MODEL
2015MY
Sedona (YP)

NUMBER
053 (REV 1, 04/07/2015)

TECHNICAL SERVICE BULLETIN

SUBJECT: SERVICE ACTION: HYDRAULIC STEERING RACK INSPECTION AND/OR REPLACEMENT (SA182)

Reading the Date Code on the Steering Rack
4 J 1 7 (dots)

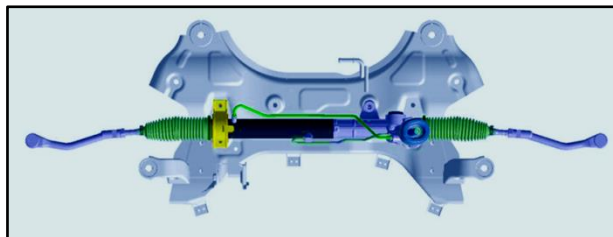
2. Locate the date code on the hydraulic steering rack. **NOTE: Refer to the table shown below to accurately read the date code information.**

3. If the rack date code matches 4 J 1 7 (dots), replace the rack with an improved part. Proceed to the Service Procedure on Page 3.
4. If the date code is different than 4 J 1 7 (dots), do NOT replace the rack. No further action is required.

1. Replace the power steering gear box with an improved one by referring to “Steering System → Hydraulic Power Steering System → Power Steering Gear Box” chapter in the applicable Workshop Manual on KGIS.
2. Perform a front end wheel alignment by referring to “Steering System → Front Suspension System → Front Alignment → Repair procedures” chapter in the applicable Workshop Manual on KGIS.
